Seismic Study – McLeod Tower

Seismic Evaluation Report

Palomar Health McLeod Tower (Building C)

Job No. 17-S023B

GROUND FLOOR & FOUNDATION PLAN		S-2	
FRANK L. HOPE & ASSOCIATES ARCHITECTS & ENGINEERS	DRAWN BY SCHEDULED	CHECKED S.E.	DATE 12-11-67
FRANK L. HOPE JR. REGISTERED ARCHITECT - CALIF.	PROJECT No. 66-26	OF 436 SHEETS

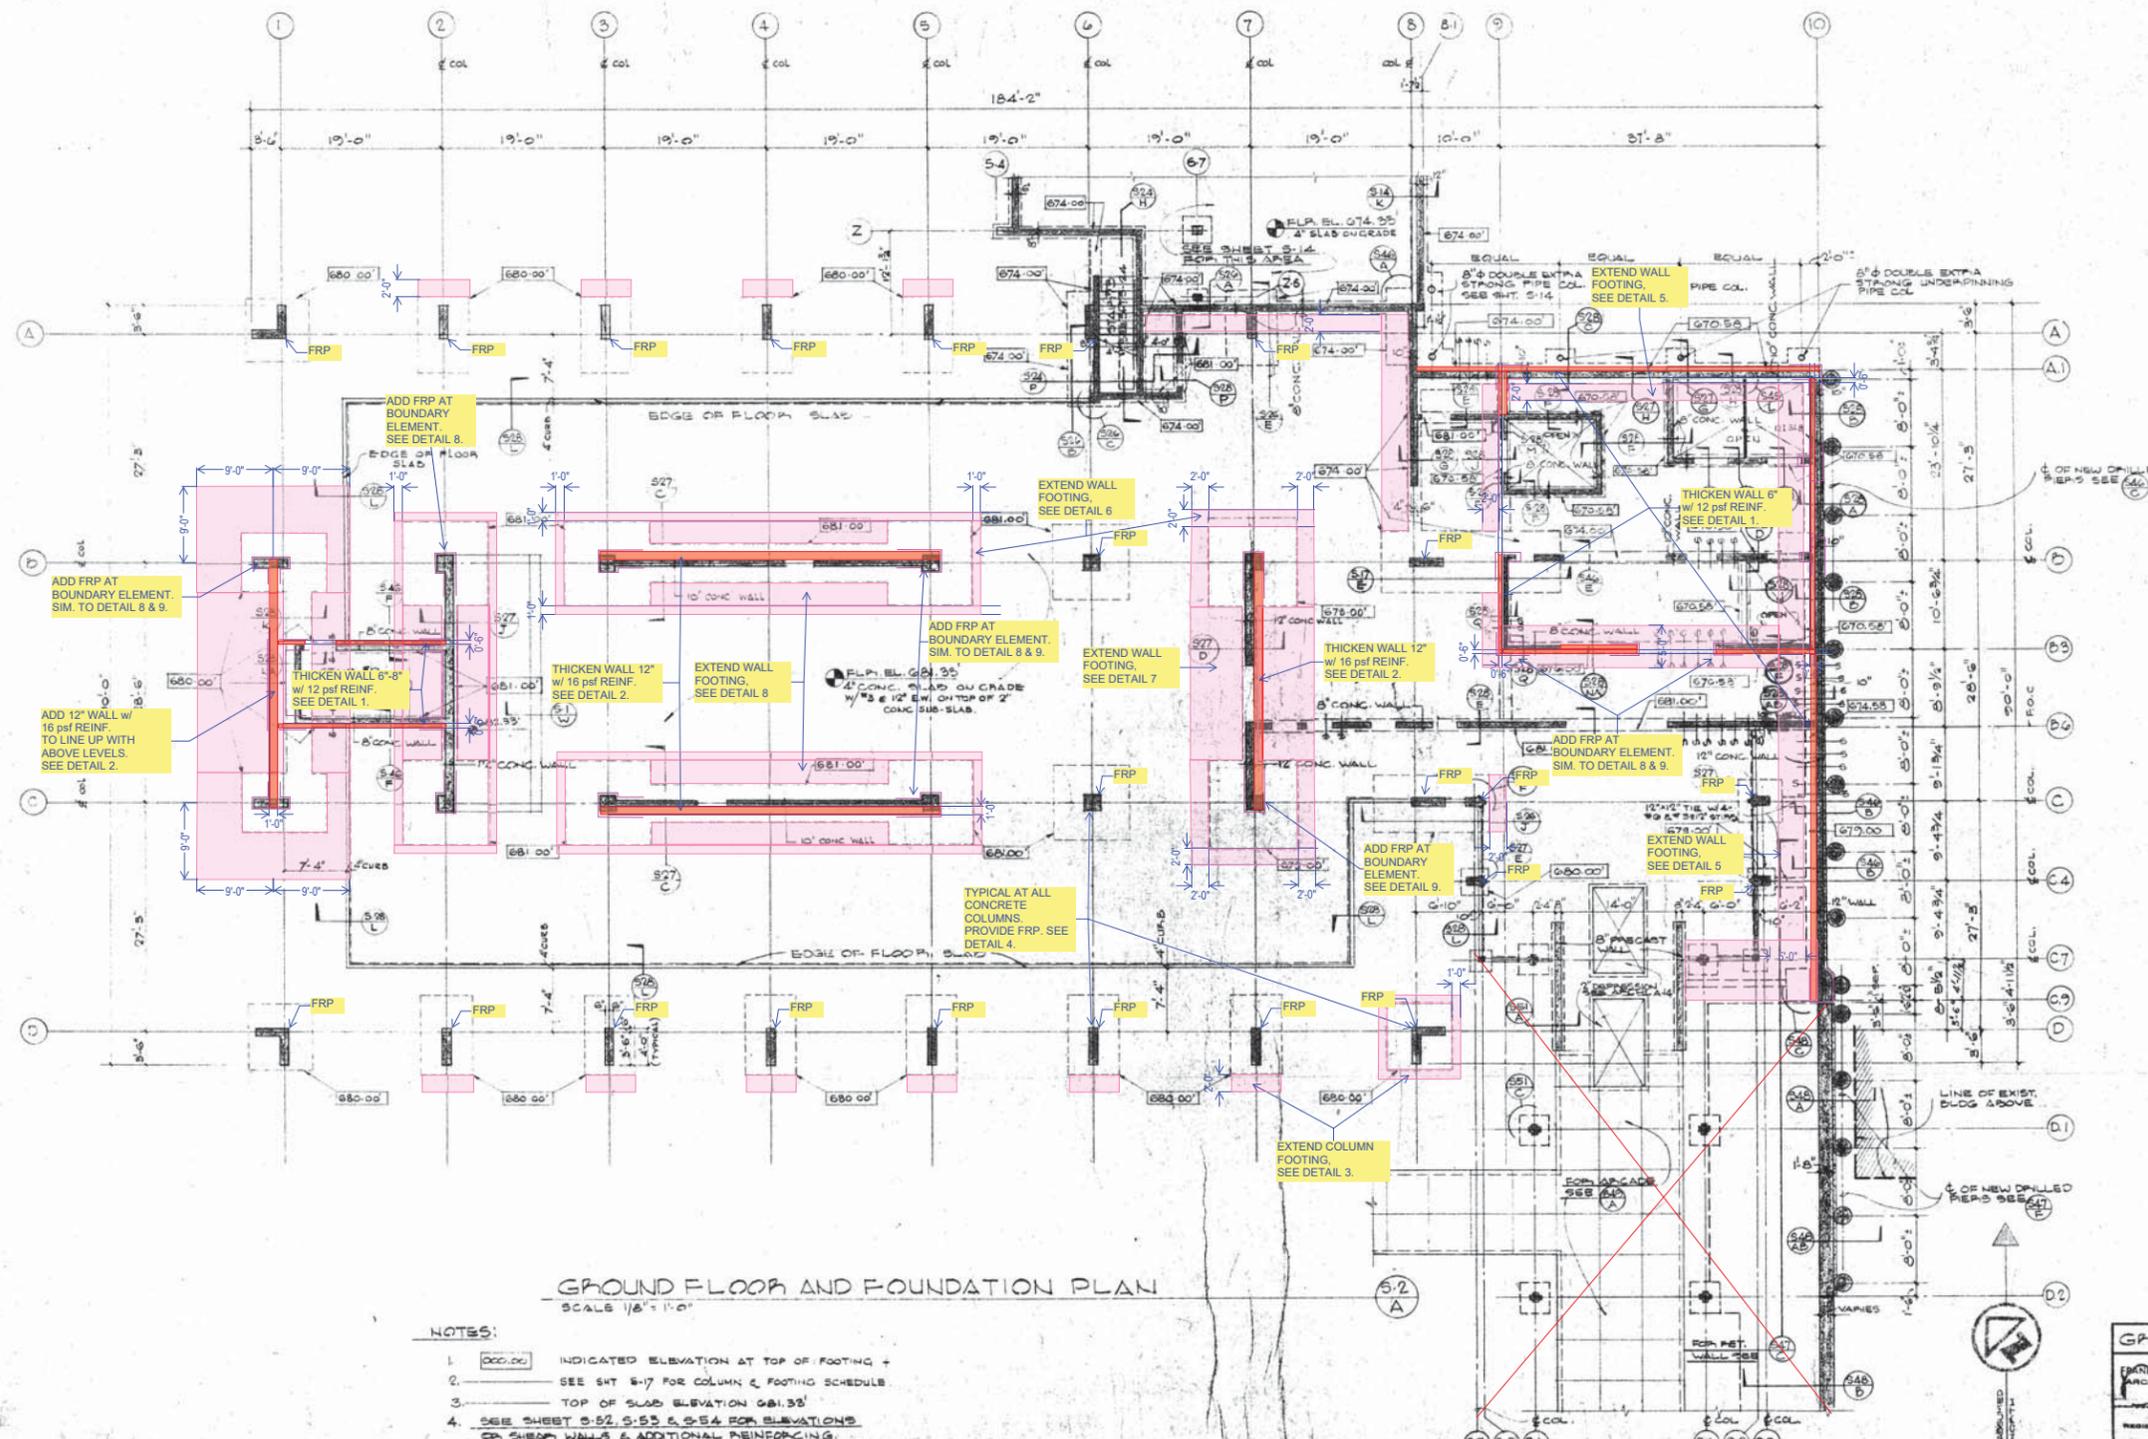
- NOTES:
1. [Elevation] INDICATED ELEVATION AT TOP OF FOOTING +
 2. SEE SHT S-17 FOR COLUMN & FOOTING SCHEDULE.
 3. TOP OF SLAB ELEVATION 681.38'
 4. SEE SHEET S-52, S-53 & S-54 FOR ELEVATIONS ON SHEAR WALLS & ADDITIONAL REINFORCING.

FOURTH FLOOR FRAMING PLAN			
FRANK L. HOPE & ASSOCIATES ARCHITECTS AND ENGINEERS	DRAWN BY SCHOLES	CHECKED SE	S-6
FRANK L. HOPE, JR. REGISTERED ARCHITECT - CALIF.	DATE 12.11.67	PROJECT No 66-26	
		OF 456 SHEETS

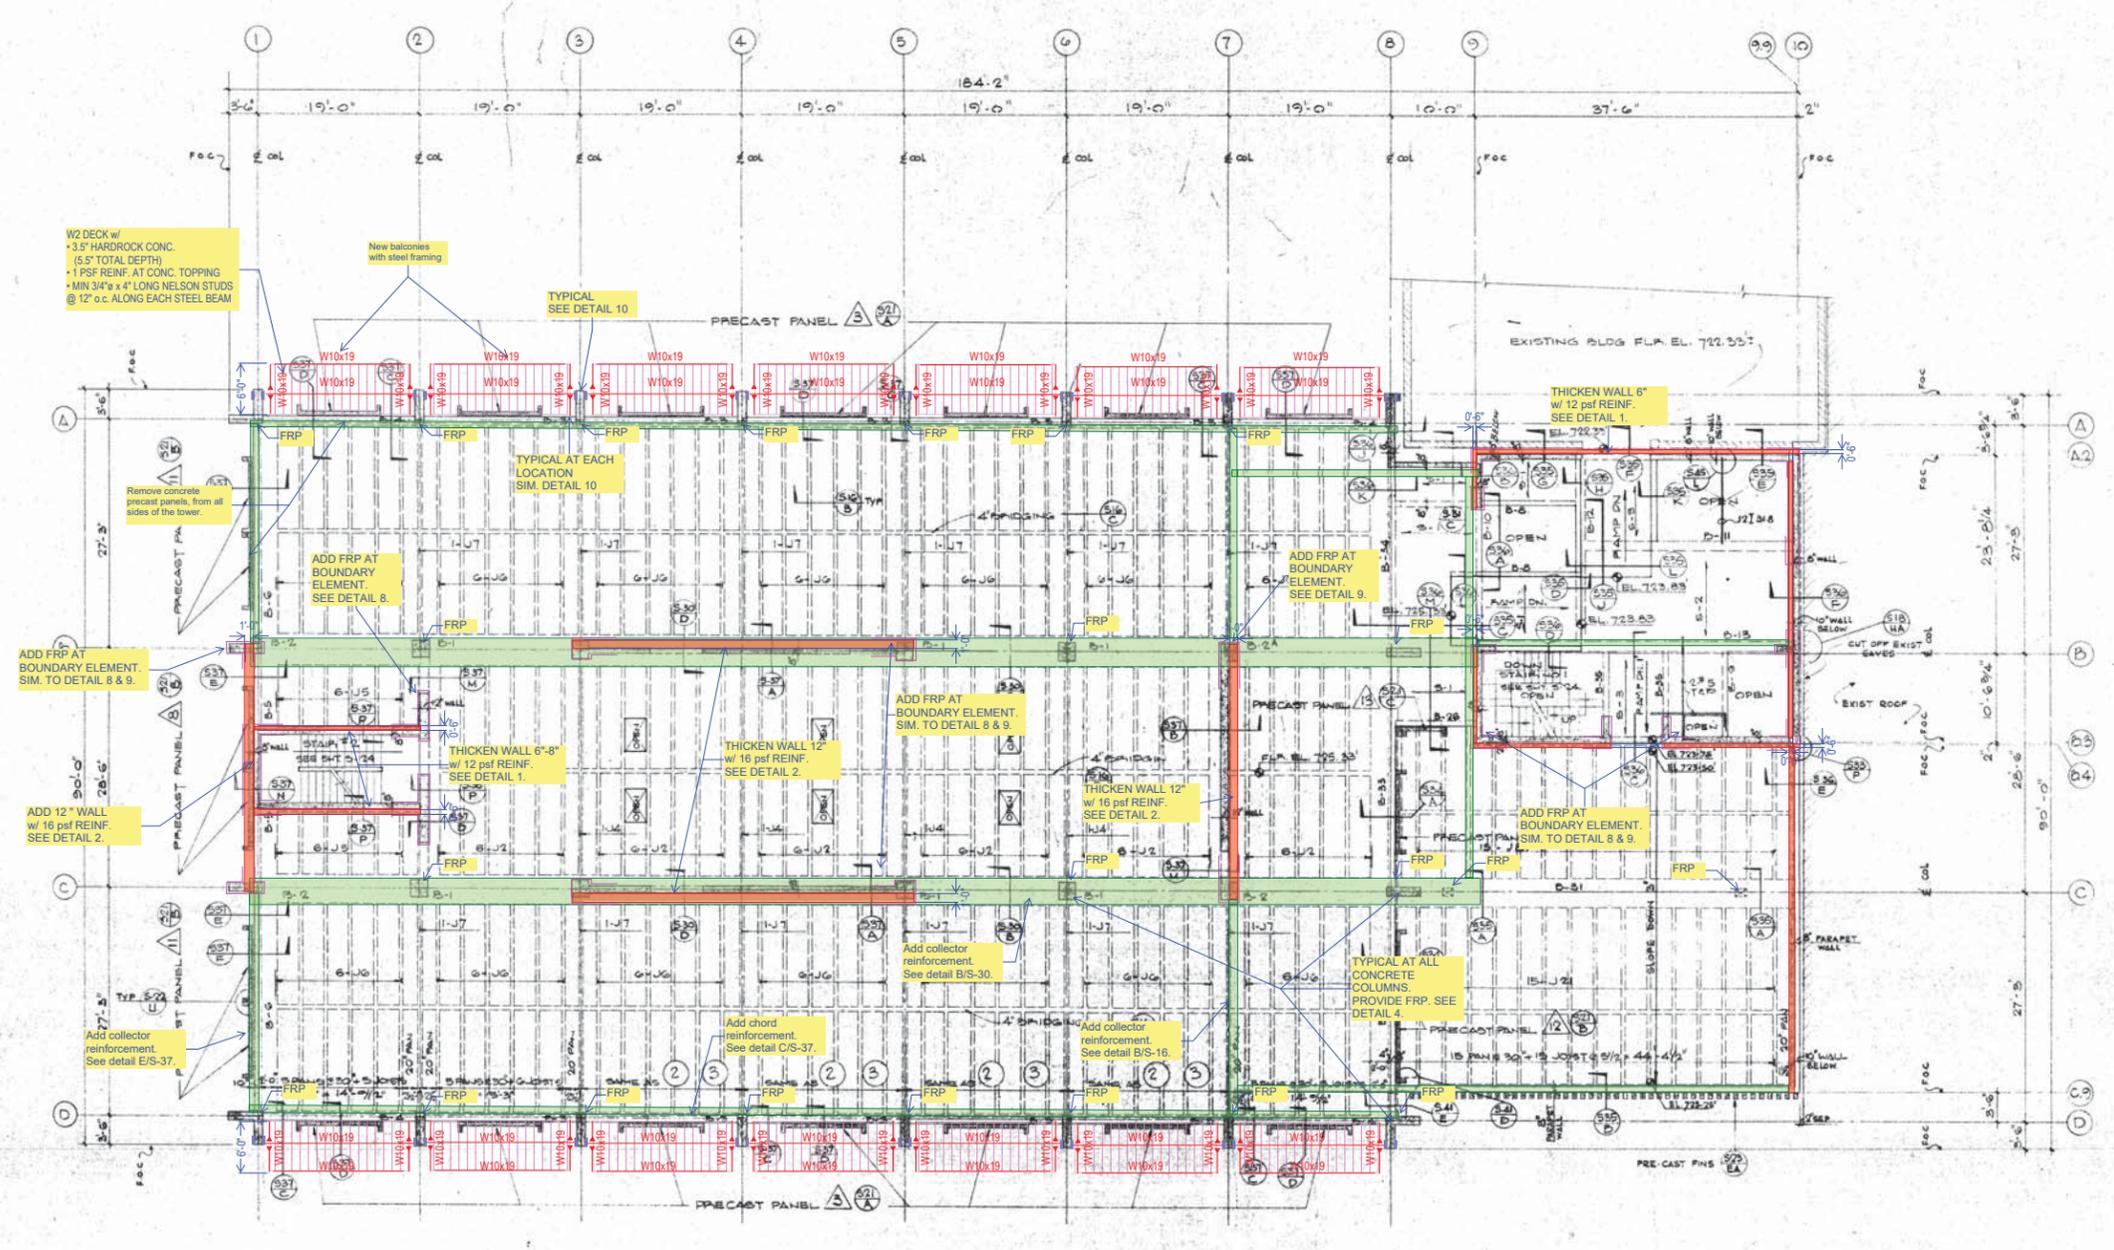
- NOTES:
1. TOP OF SLAB ELEVATION 725.55' (EXCEPT AT RAMPS AND TERRACE)
 2. SEE SHEET S-16 FOR JOIST SCHEDULE
 3. SEE SHEET S-17 FOR COLUMN SCHEDULE
 4. SEE SHEET S-19 & 20 FOR BEAM SCHEDULE
 5. SEE SHEET S-27 FOR SLAB SCHEDULE
- △ DENOTES PRECAST PANEL NUMBER - SH S-2

FIFTH FLOOR FRAMING PLAN			
 FRANK L. HOPE & ASSOCIATES REGISTERED ARCHITECTS - CIVIL	DRAWN BY S.E. CHECKED BY S.E. DATE 12.11.67	PROJECT No. 66-24 OF 496 SHEETS	S-7

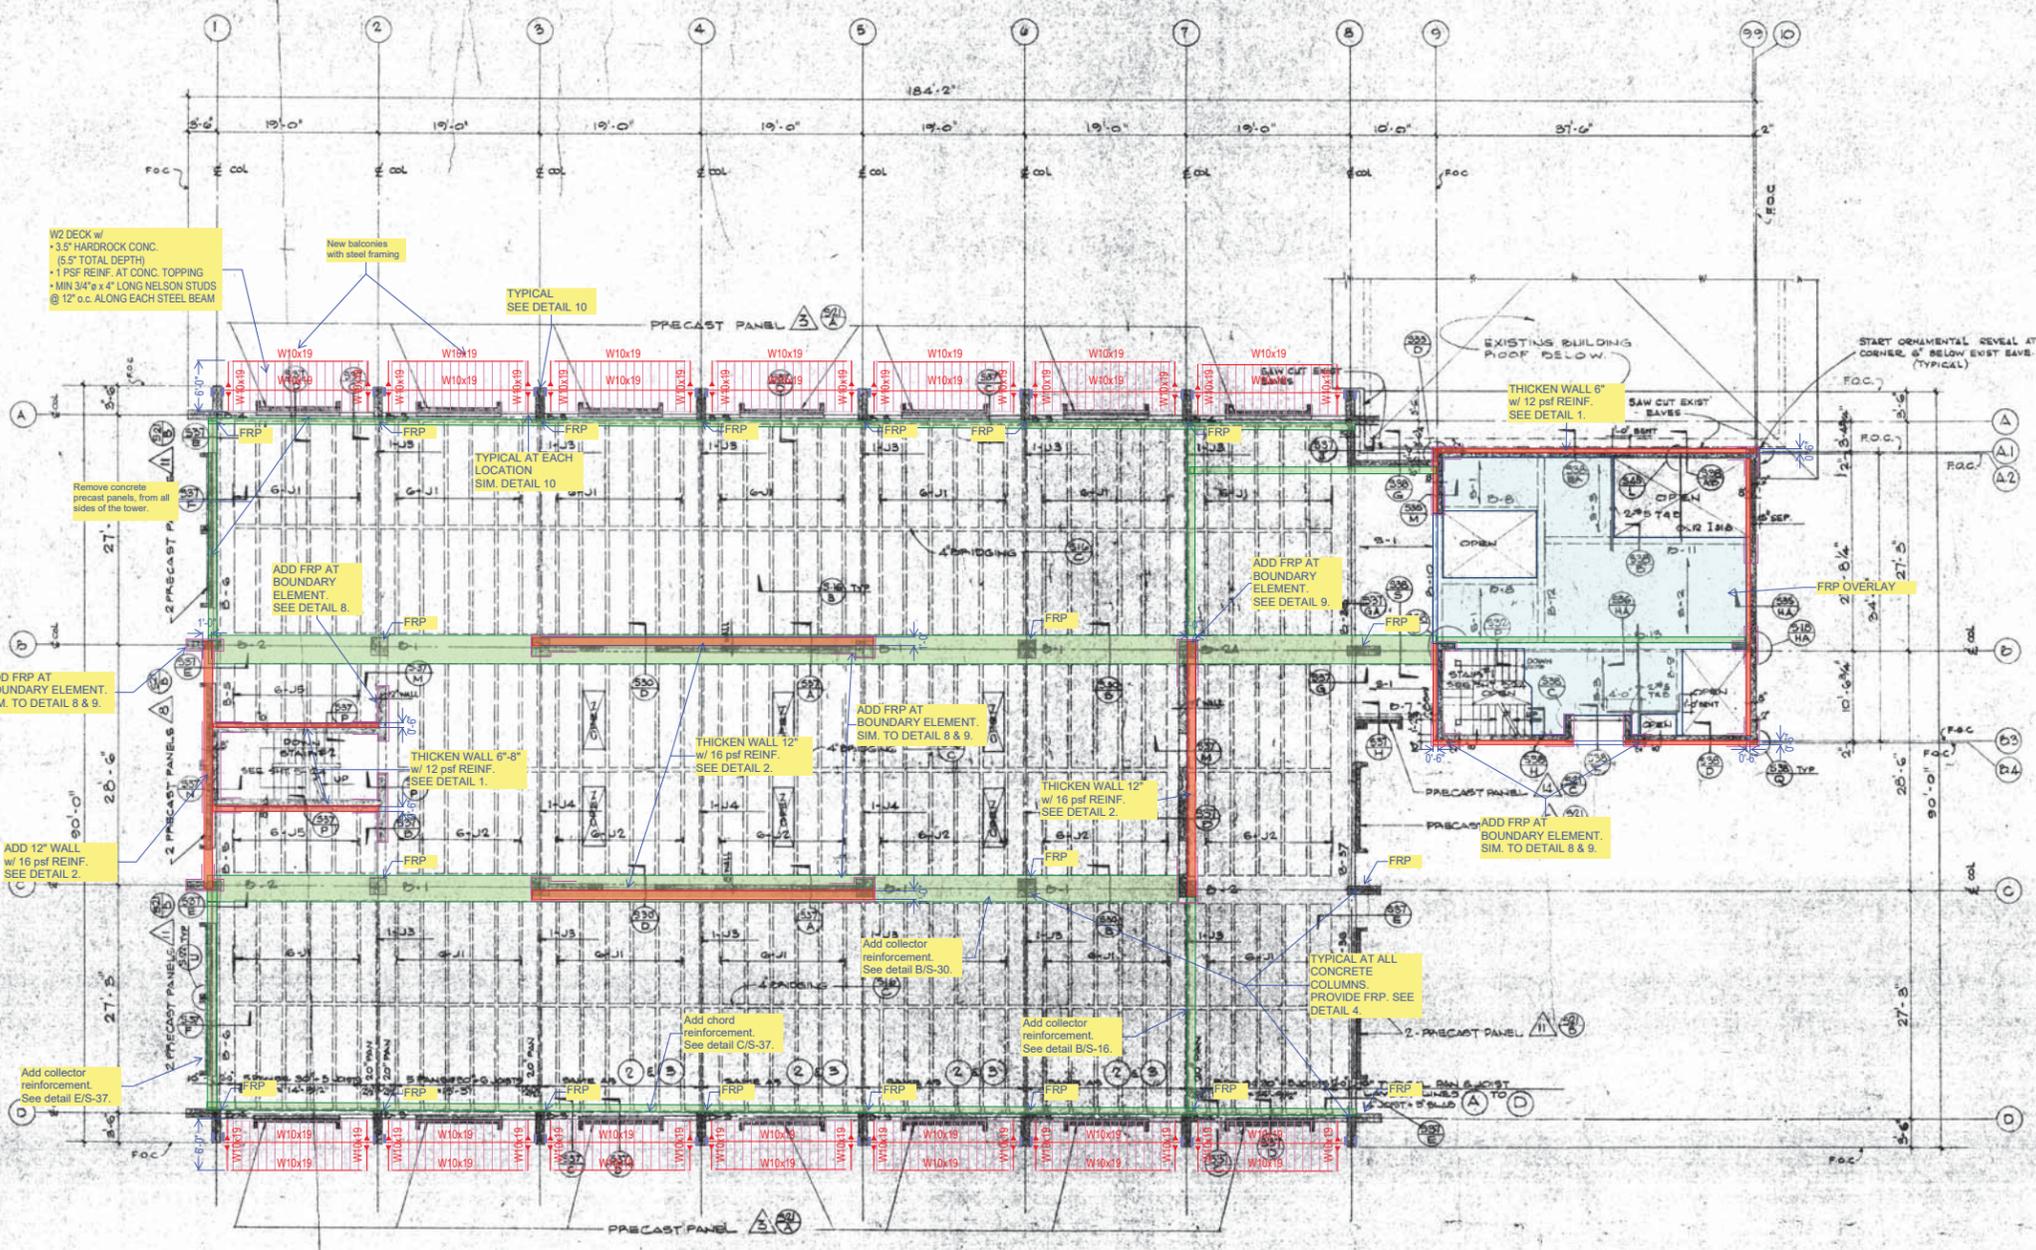
- NOTES:
1. TOP OF SLAB ELEVATION 737.93
 2. SEE SHEET S-16 FOR JOINT SCHEDULE
 3. SEE SHEET S-27 FOR SLAB SCHEDULE
 4. SEE SHEETS 192590 FOR BEAM SCHEDULES
 5. SEE SHEET S-17 FOR COLUMN SCHEDULE
- △ DENOTES PRECAST PANEL NUMBER. SEE SH S-21 & S-22

EXISTING WALL FOUNDATION STRENGTHENING SECTION **5**
1/2"=1'-0"

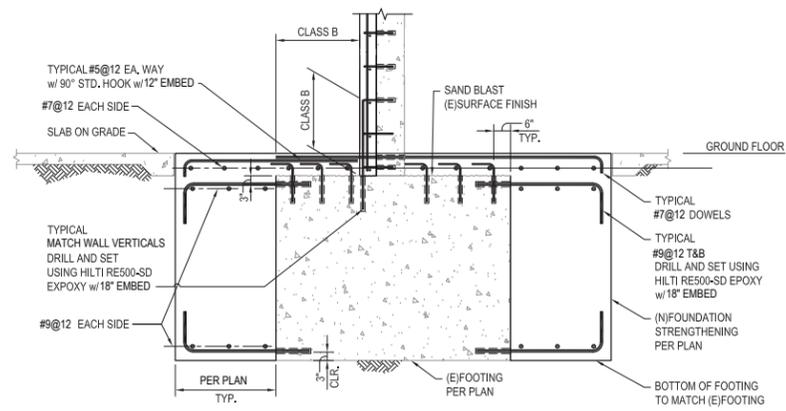
- NOTES
1. DO NOT CUT EXISTING REBAR FROM DRILLING, NO EXCEPTIONS.
 2. ALL EPOXY DOWELS SHALL BE HILTI RE-500SD.
 3. FOR BALANCE OF INFORMATION SEE 2/PS601.

EXISTING WALL FOUNDATION STRENGTHENING SECTION **6**
1/2"=1'-0"

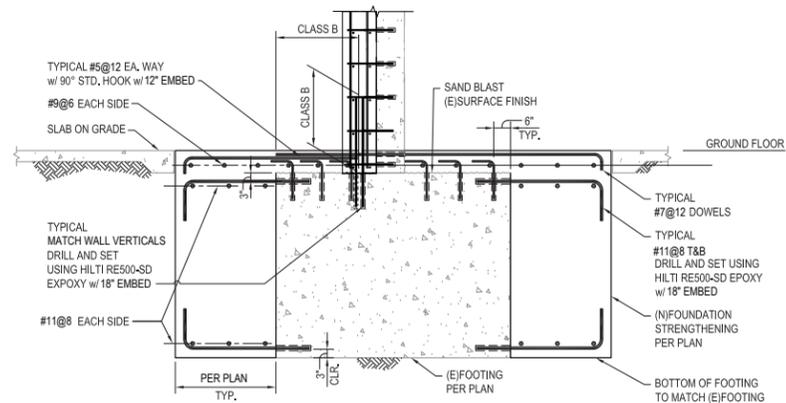
- NOTES
1. DO NOT CUT EXISTING REBAR FROM DRILLING, NO EXCEPTIONS.
 2. ALL EPOXY DOWELS SHALL BE HILTI RE-500SD.
 3. FOR BALANCE OF INFORMATION SEE 2/PS601.

EXISTING WALL FOUNDATION STRENGTHENING SECTION **7**
1/2"=1'-0"

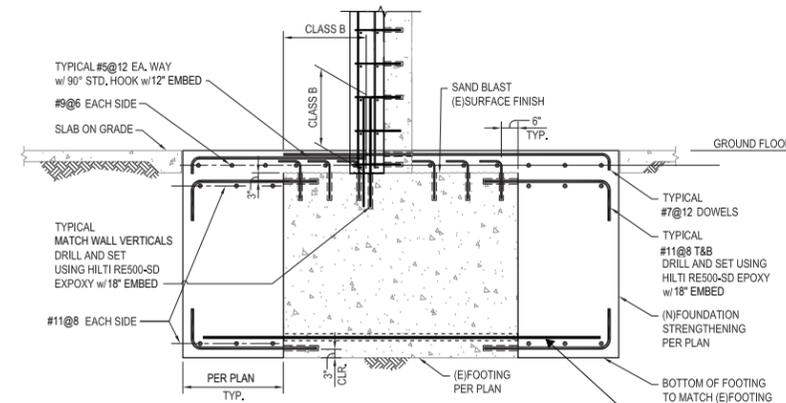
- NOTES
1. DO NOT CUT EXISTING REBAR FROM DRILLING, NO EXCEPTIONS.
 2. ALL EPOXY DOWELS SHALL BE HILTI RE-500SD.
 3. FOR BALANCE OF INFORMATION SEE 2/PS601.

**TYPICAL SHEAR WALL JAMB
FRP WRAP DETAIL**

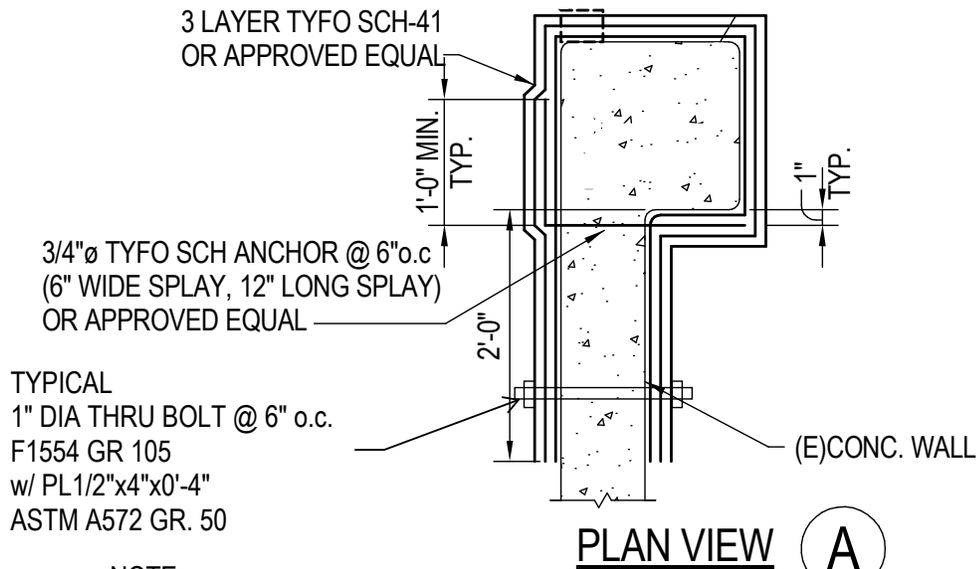
1. WHERE FRP OCCURS, ROUND CORNERS WITH 1" MINIMUM RADIUS, 1" MINIMUM COVING RADIUS AT REENRANT CORNERS.
2. BACKFILL ANCHOR HOLES WITH EPOXY.

TYPICAL SHEAR WALL JAMB
FRP WRAP DETAIL

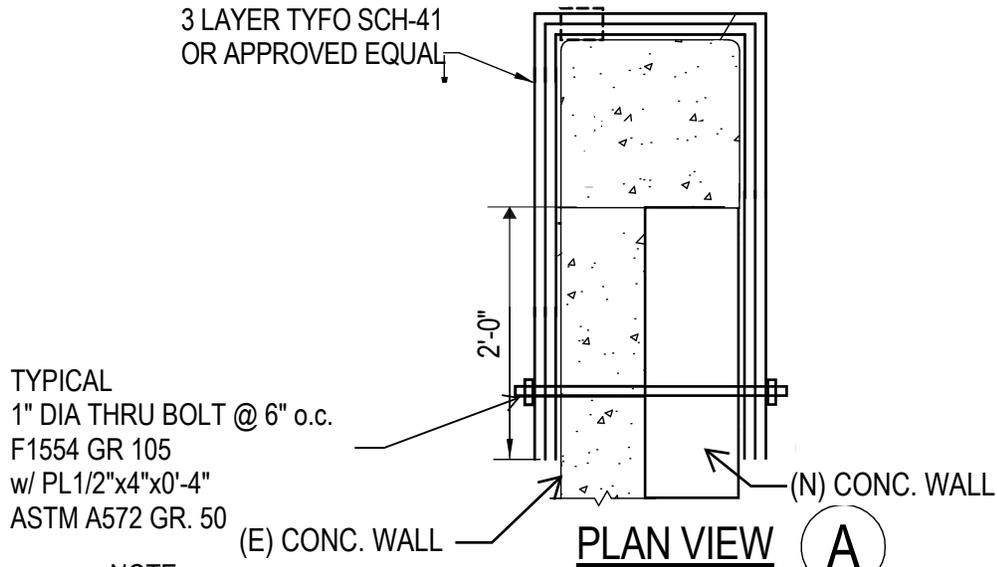
Recommended Carbon Fiber Wrapping at Existing
Wall Jamb to Increase Confinement (Conceptual)

1. WHERE FRP OCCURS, ROUND CORNERS WITH 1" MINIMUM RADIUS, 1" MINIMUM COVING RADIUS AT REENTRANT CORNERS.
2. BACKFILL ANCHOR HOLES WITH EPOXY.
